City of Turlock
Well 38 Arsenic Mitigation
And ICF Treatment

ADDENDUM NO. 2

**FOR: CITY OF TURLOCK
WELL 38 ARSENIC MITIGATION
AND ICF TREATMENT**

June 24,2020

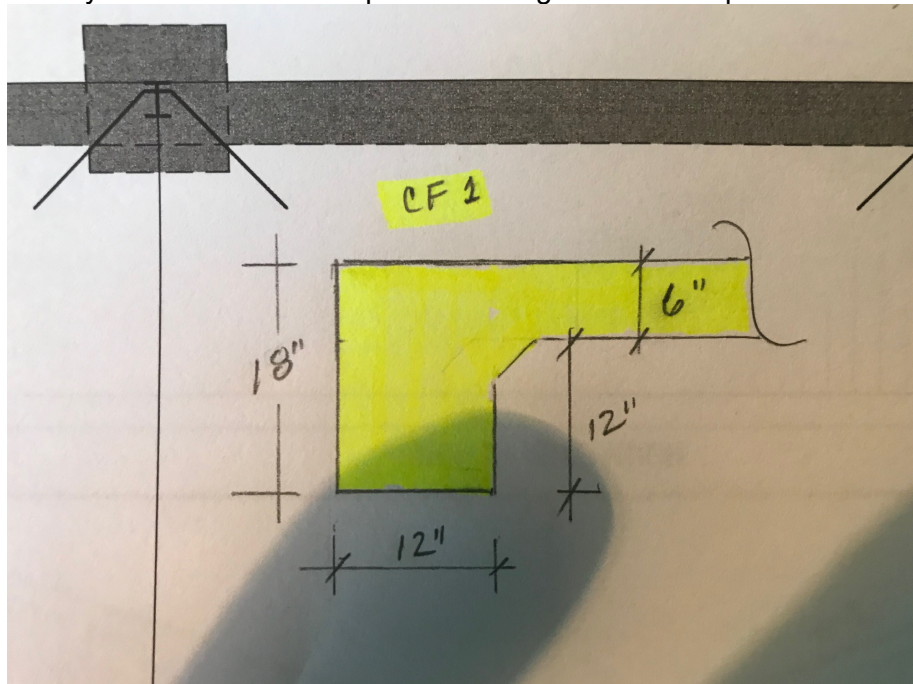
Question No. 49: Drawing E2.1 shows various electrical conduits to the well pump, MCC and panel L1 being installed underground. Is it the intention to excavate the existing building slab to

install these conduits or should all new conduits inside the existing well building be installed exposed on the walls and ceiling?

Answer No. 49: Concrete removal in the well building has been added to the Demolition Plan on C-3 and attached to this Addendum. The contractor shall replace the concrete in kind once conduit is placed and estimated extents of slab are shown on the revised Sheet P10-01 attached to this Addendum. See Plan Revision Item 11 this Addendum.

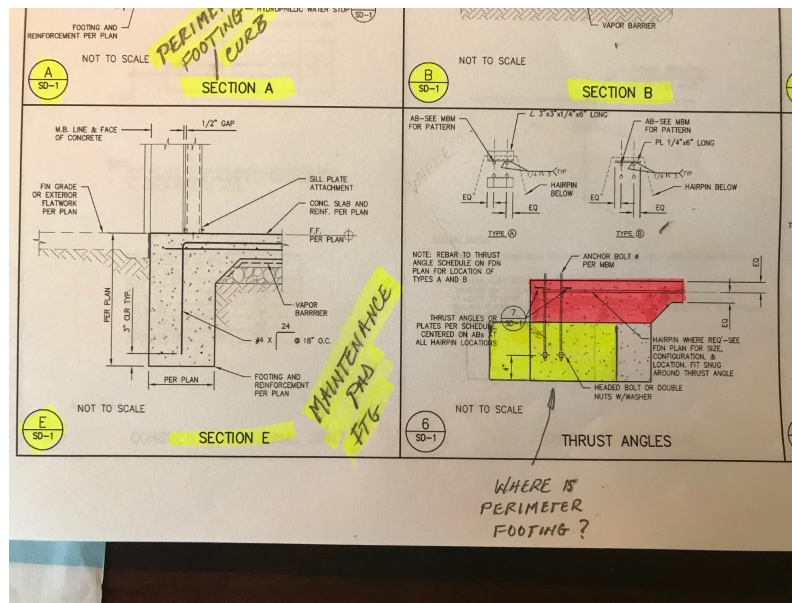
Question No. 52: Footings shown on S60-01 (F1 & CF1) do not match/line-up with Detail 6 of SD-1. Please clarify elevation on from top of F1 footing in relationship to Finished Floor.

Answer No. 52: Refer to A SD-1 and the depth of CF1 is 12" not 18"

Sheet S50-02

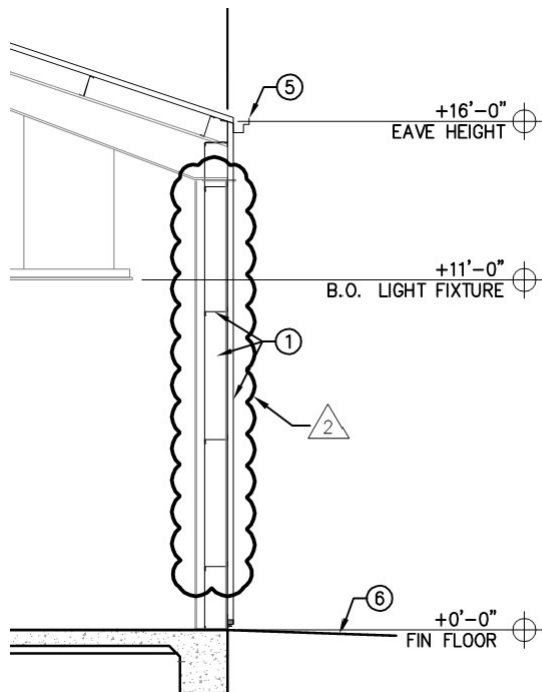
Question No. 51: For the chain link fence for the chemical storage building. Can they either provide a written spec. and/or add pipe sizes, wire gauges etc. to the drawings?

Answer No. 51: The poles for the chain link fence shall be 3" diameter standard pipe with 9 gauge wire. See Revision Item 9 this Addendum

**4. THE POLES FOR THE CHAIN LINK FENCE
SHALL BE 3" DIAMETER STANDARD PIPE WITH 9 GAUGE WIRE.**

CIVIL
DEMOLITION PLAN

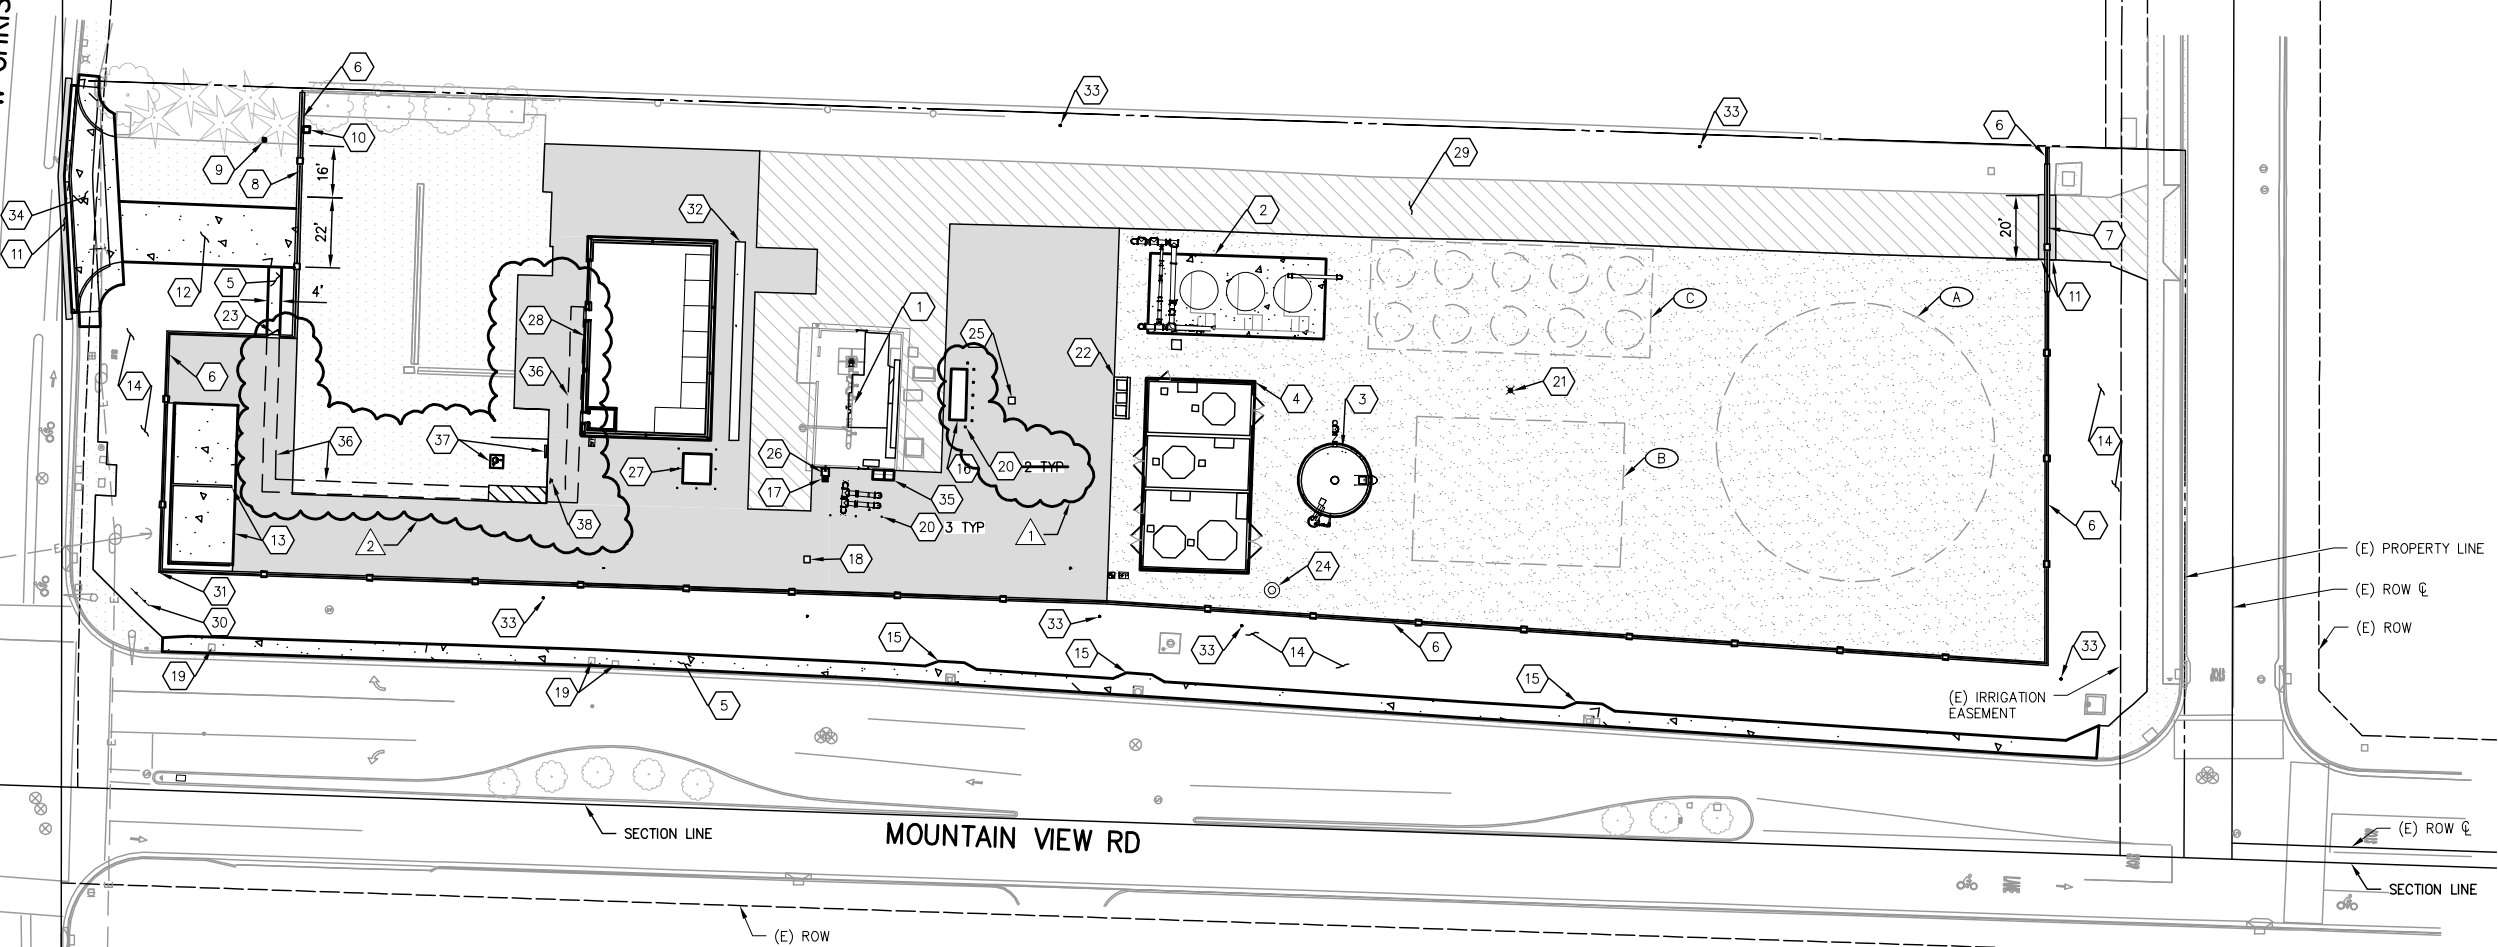
Question No. 21: Please confirm Demolition Call-out [4] building foundation is scheduled for demolition and removal as well. If this foundation is scheduled for removal please provide a thickness for basis of bid.

Question No. 29: Demolition Call-out [7]. Please confirm flush saw cut & demo/removal of 4' wall will be permitted on existing slab.

Question No. 31: Demolition Call-out [17]. Please confirm existing bollards for removal? Call-out is not clear if City wants specific bollard(s) removed or all of them.

Question No. 47: Confirm Existing Water piping and Electrical Conduits will be Capped and abandoned in Place. Callout 14 on Sheet C-3 states to remove.

Answer No. 21: *Confirmed callout 4 on Sheet C-3 includes demolition and removal of maintenance shed foundation. No Record Drawings of the existing Maintenance Shed are available to confirm thickness.*

Answer No. 29: *The mulch pile walls shall be over cut by 1" and removed per Callout 7 on Sheet C-3. Then patched to provide a smooth surface.*

Answer No. 31: Confirmed that all of the bollards within the demolition hatch shown on Sheet C-3 shall be removed.

Answer No. 47: Where accessible outside of the existing concrete slab, the water piping shall be removed. In locations where the water piping goes under the concrete slabs that remain shall be capped and abandoned in place.

SHEET
C-5

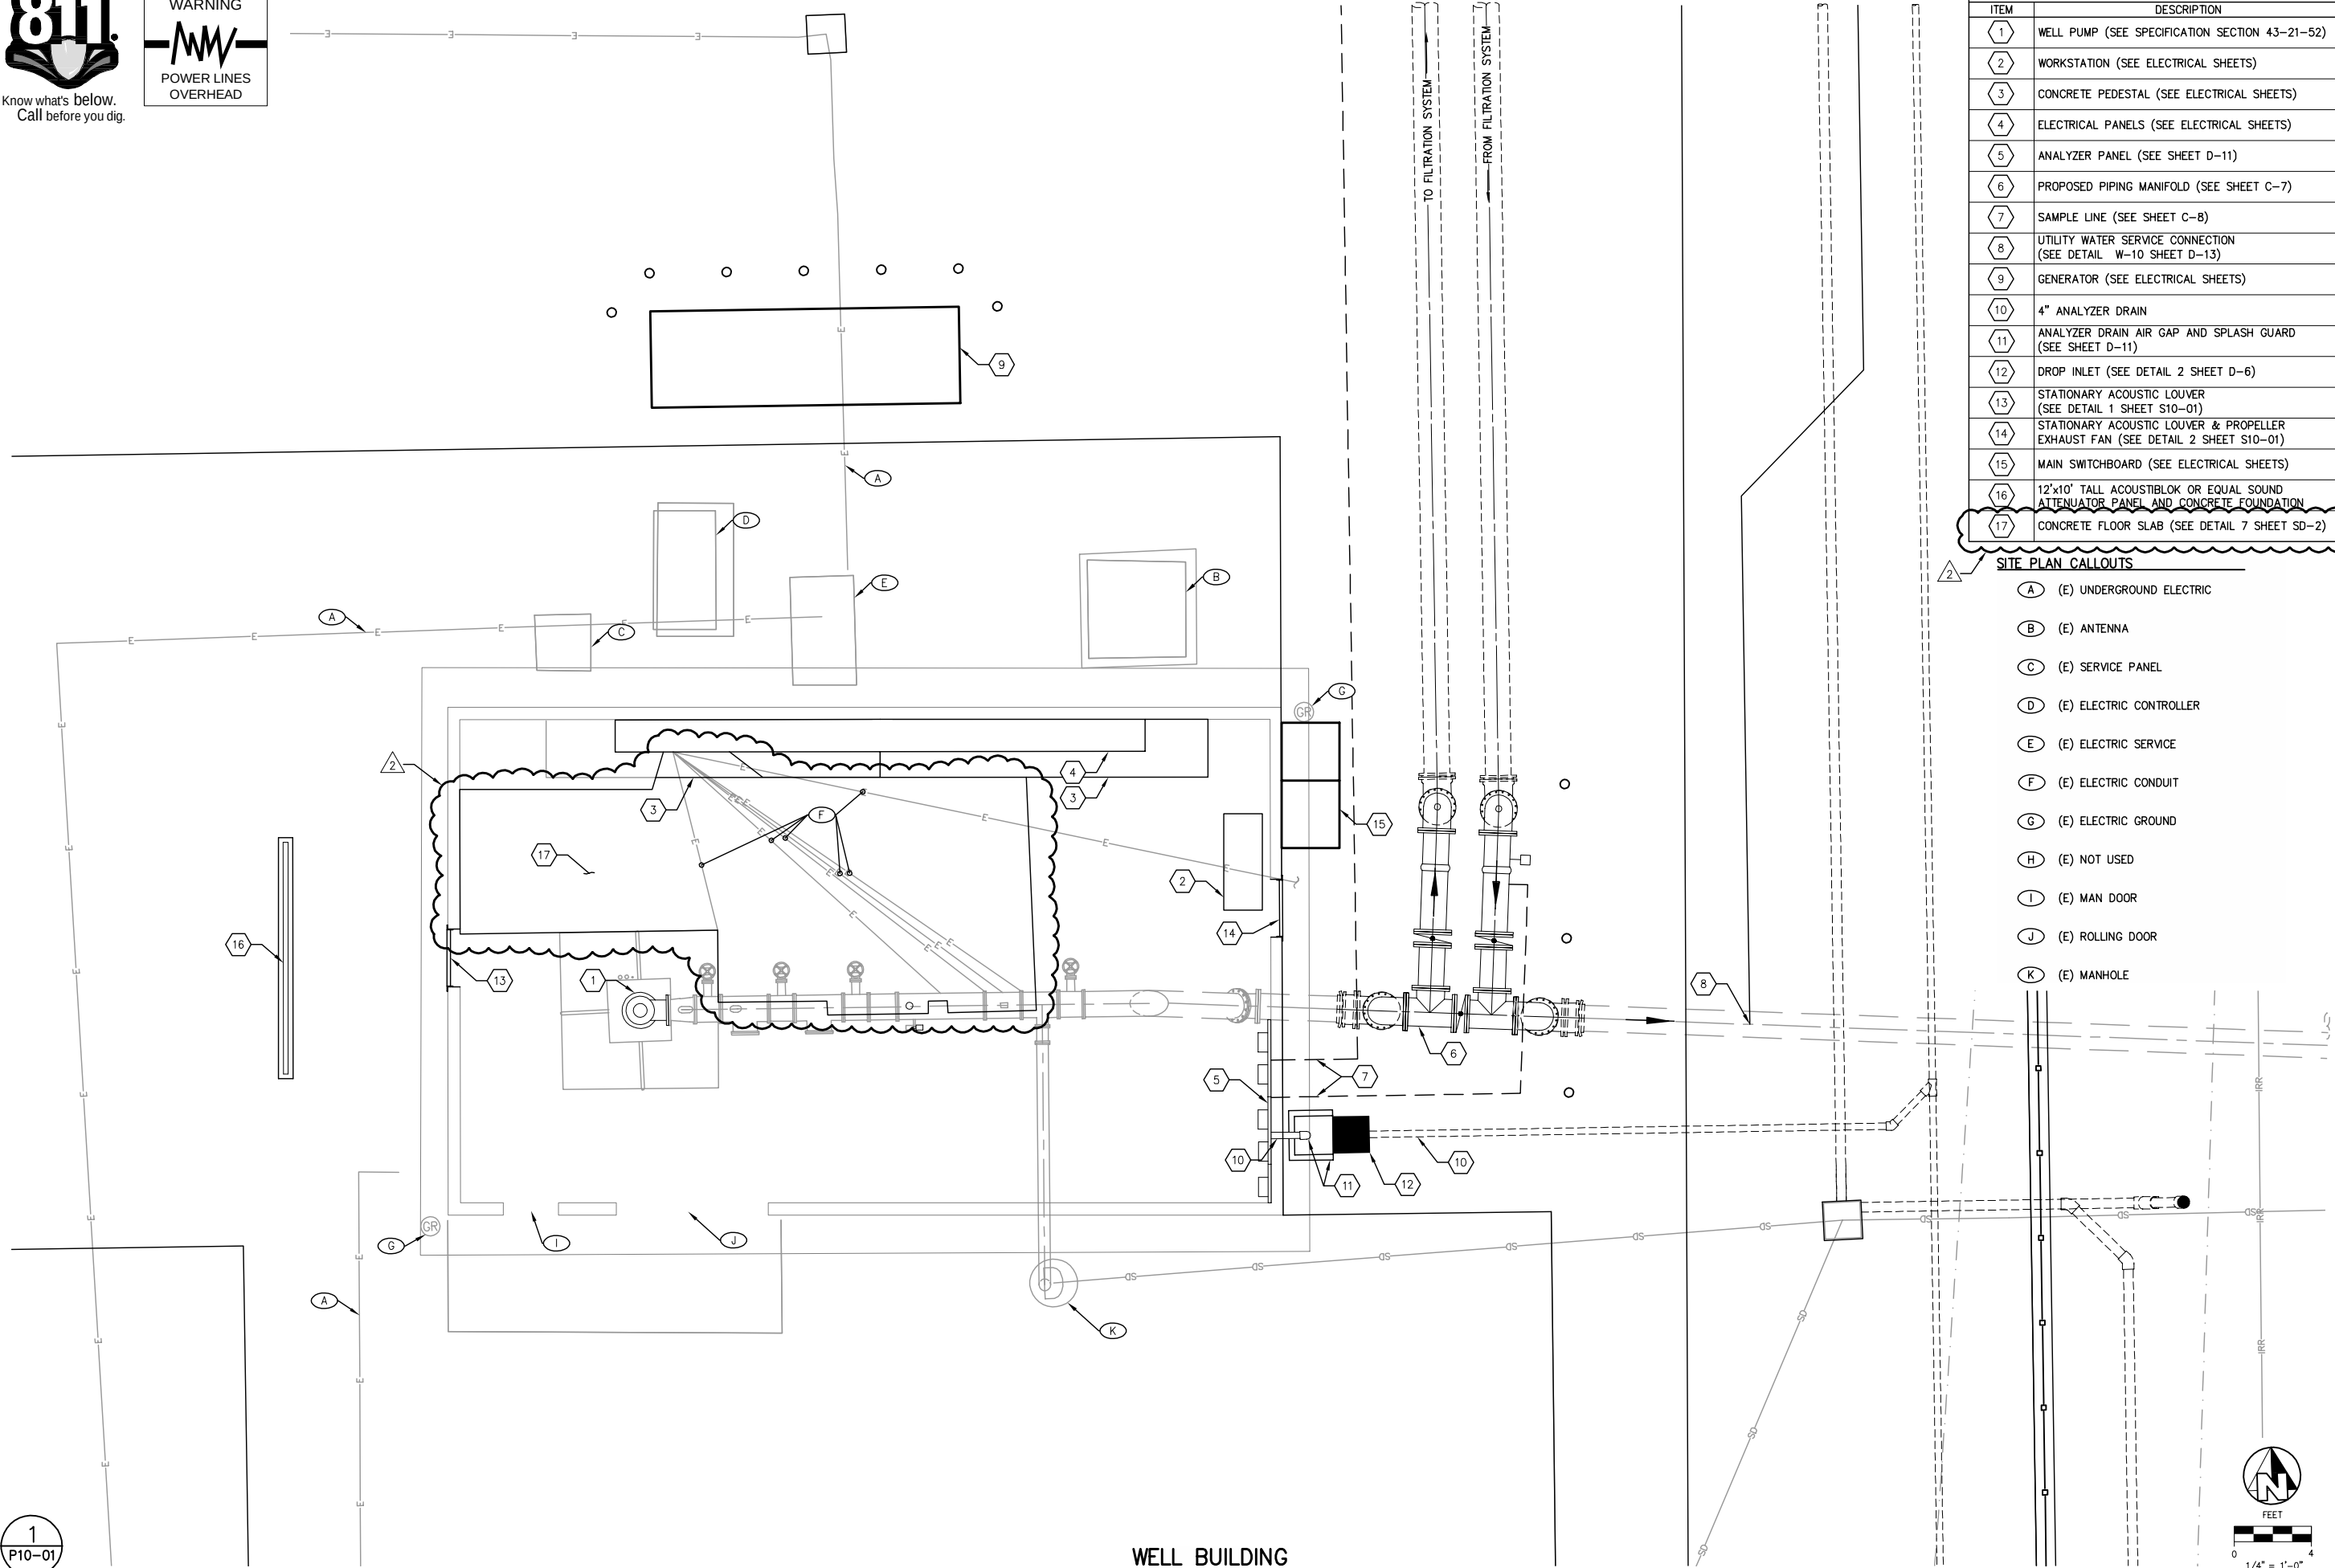
Question No. 18: Please confirm that removal of the dirt and debris piles at the north half of the site is to be included in the Contractor's scope of work. Is this off-haul included in the estimated cut volume on Sheet C-5?

Answer No. 18: *The removal of the dirt and debris piles at the north half of the site shall be included in the Contractor's scope of work. The estimated informational grading quantities shown on Sheet C-5 do not include the debris and dirt piles.*
